AMENDMENT 2 AMENDEMENT 2

**Plugs, socket-outlets and couplers for industrial purposes –
Part 2: Dimensional interchangeability requirements for pin and contact-tube
accessories**

This amendment has been prepared by subcommittee 23H: Industrial plugs and socket-outlets, of IEC technical committee 23: Electrical accessories.

Standard sheet 2-I

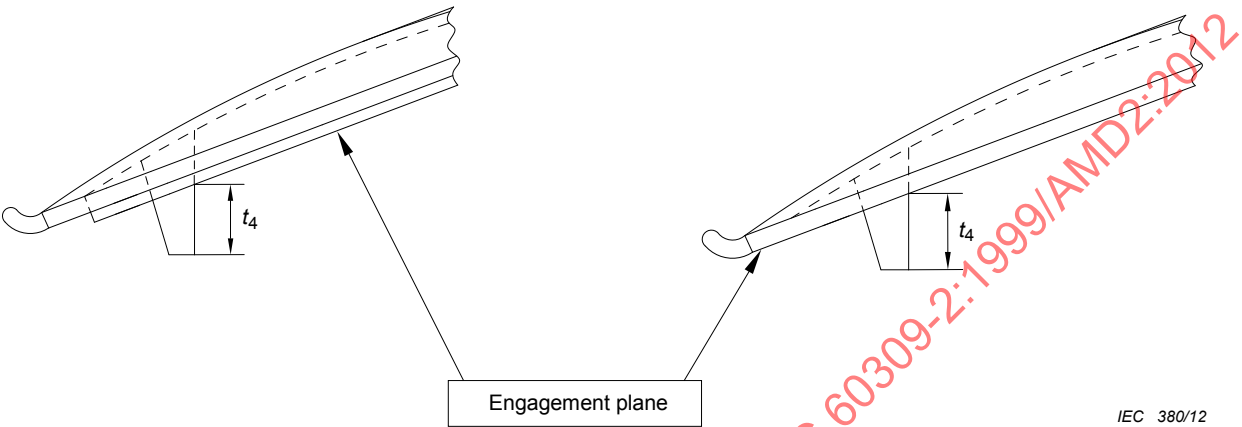
Add the following after the existing table:

The dimension t_4 of the retaining device is taken from the engagement plane (see following figure).

The dimension referred as “5 max” is taken on the engagement plane (see following figure).

Standard sheet 2-III
(continuation 1)

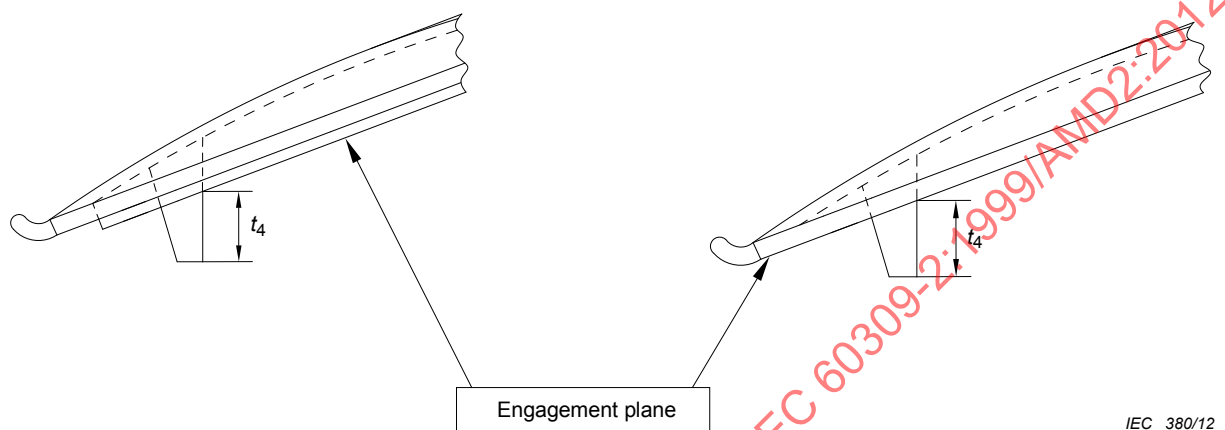
Add the following after the existing drawing:

The dimension t_4 of the retaining device is taken from the engagement plane (see following figure).

The dimension referred as “5 max” is taken on the engagement plane (see following figure).

Standard sheet 2-IIIa

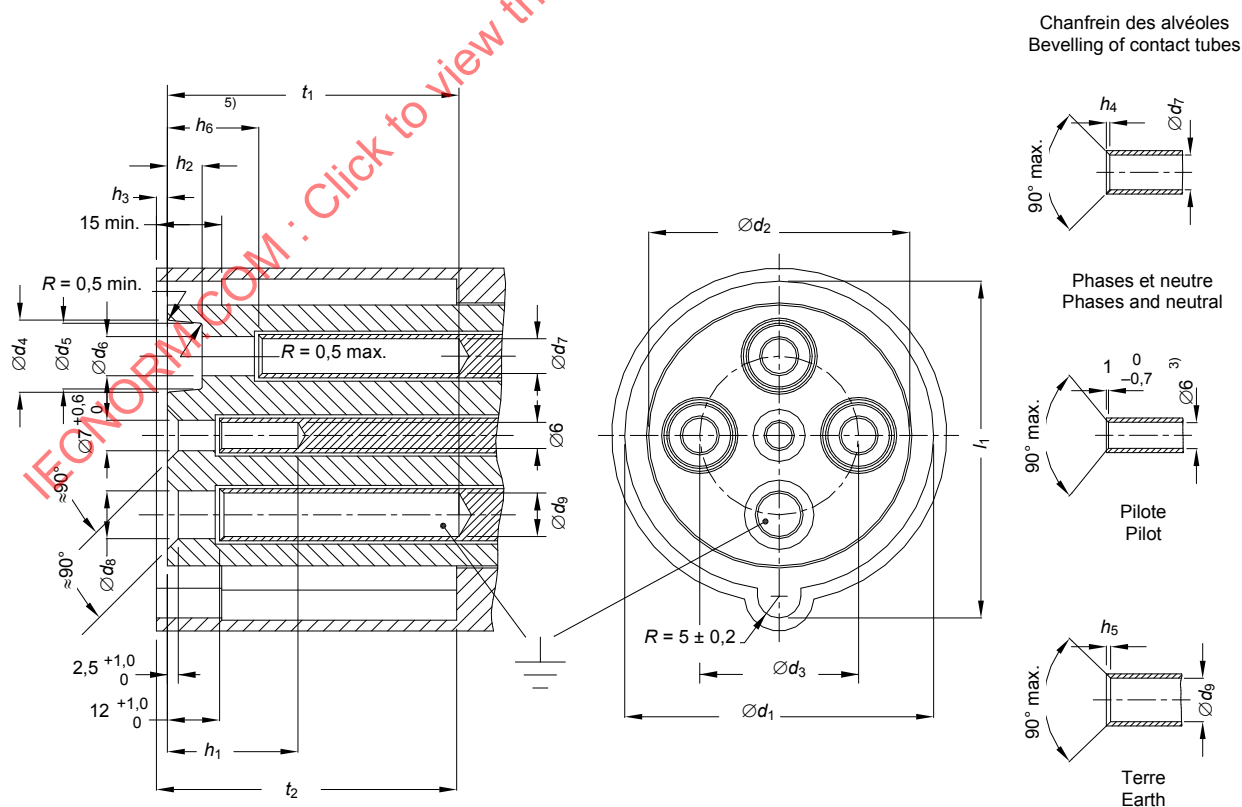
Replace the existing drawing – introduced by amendment 1 – by the following:

Standard sheet 2-IVa

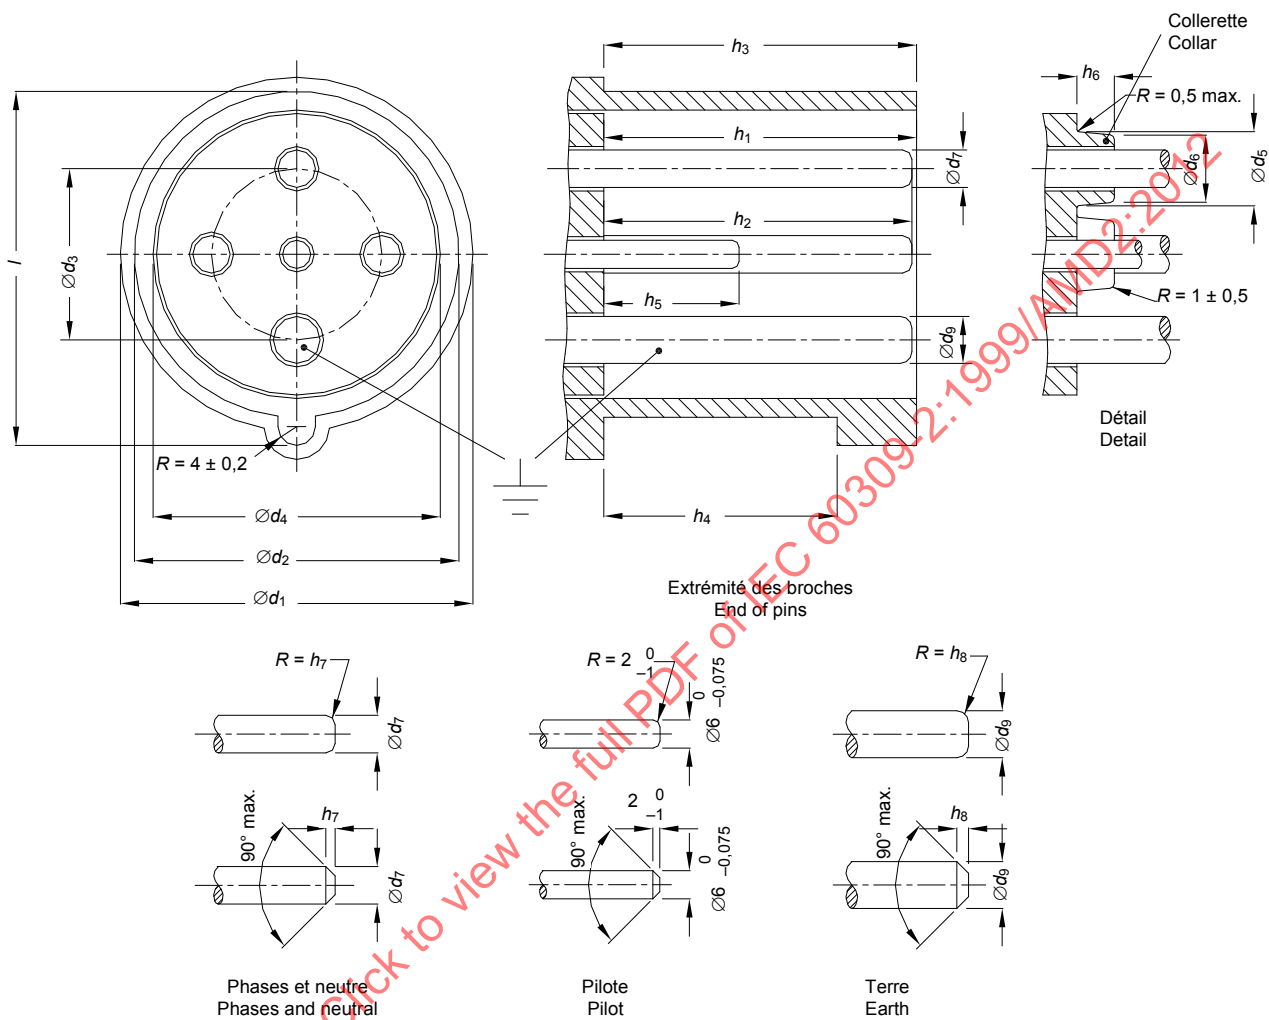
Replace the first two drawings – introduced by amendment 1 – by the following:

Feuille de normes 2-I (suite 1)

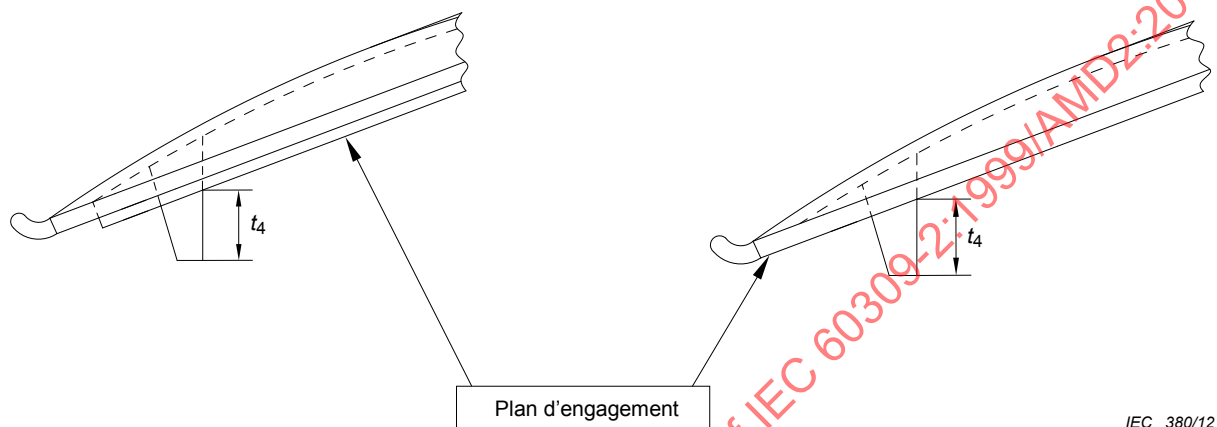
Ajouter ce qui suit après le tableau existant:

La cote t_4 du dispositif de retenue est mesurée à partir du plan d'engagement (voir le dessin ci-dessous).

La cote "5 max" est mesurée sur le plan d'engagement (voir le dessin ci-dessous).

Feuille de normes 2-III (suite 1)

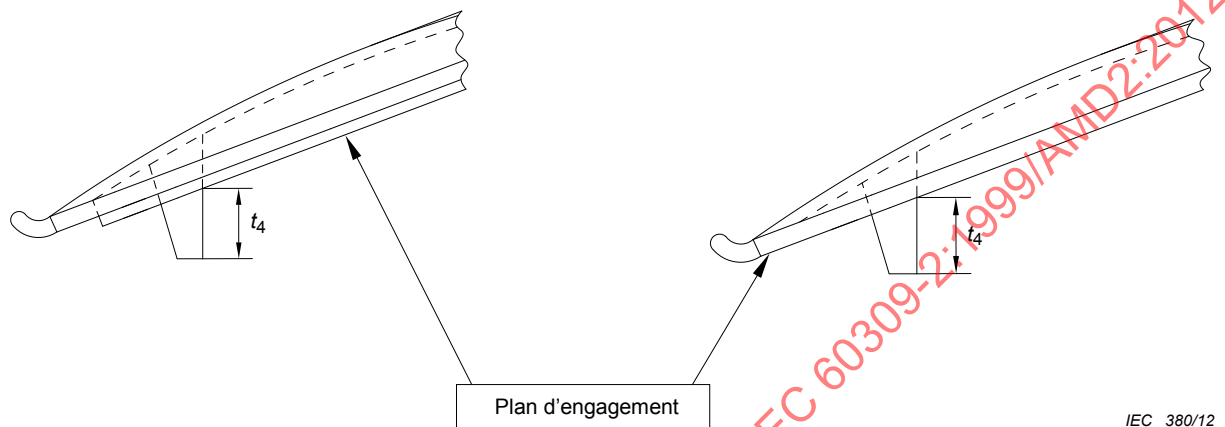
Ajouter ce qui suit après le dessin existant:

La cote t_4 du dispositif de retenue est mesurée à partir du plan d'engagement (voir le dessin ci-dessous).

La cote “5 max” est mesurée sur le plan d'engagement (voir le dessin ci-dessous).

Feuille de normes 2-IIIa

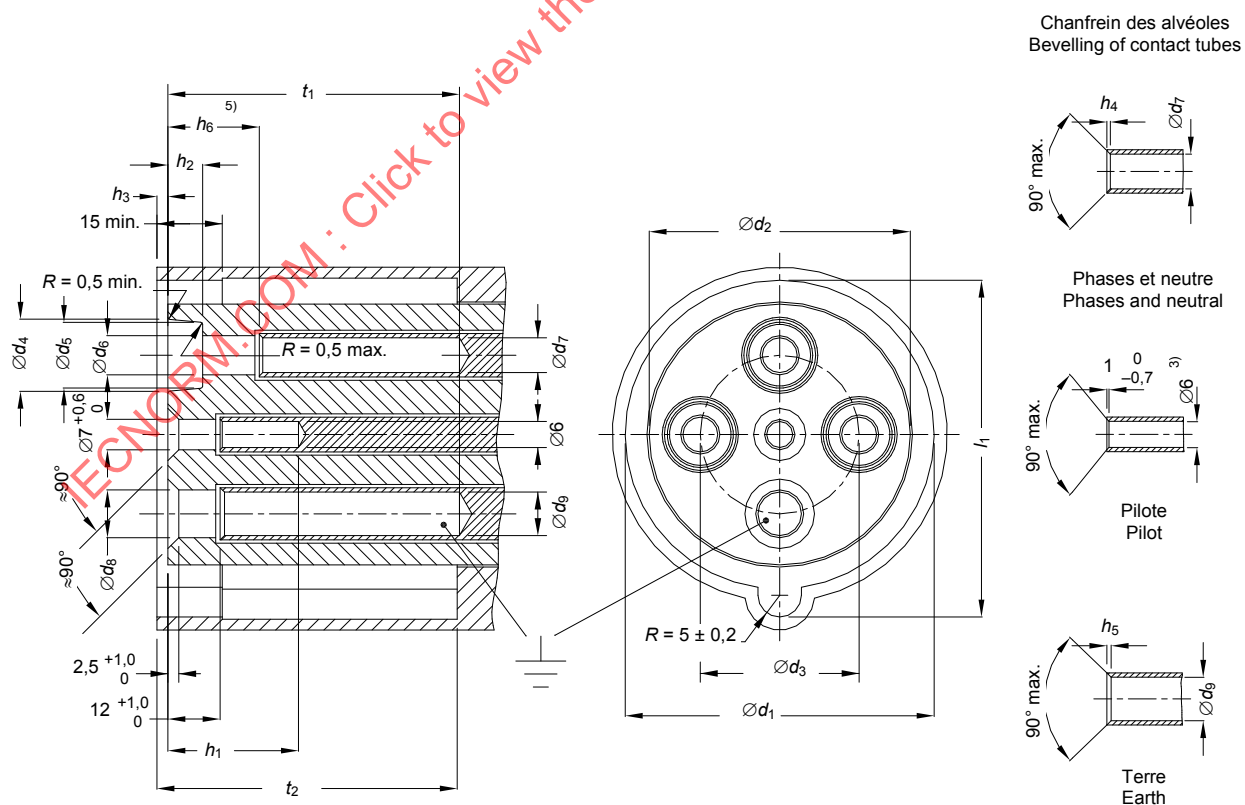
Remplacer le dessin existant – introduit par l'amendement 1 – par le suivant:
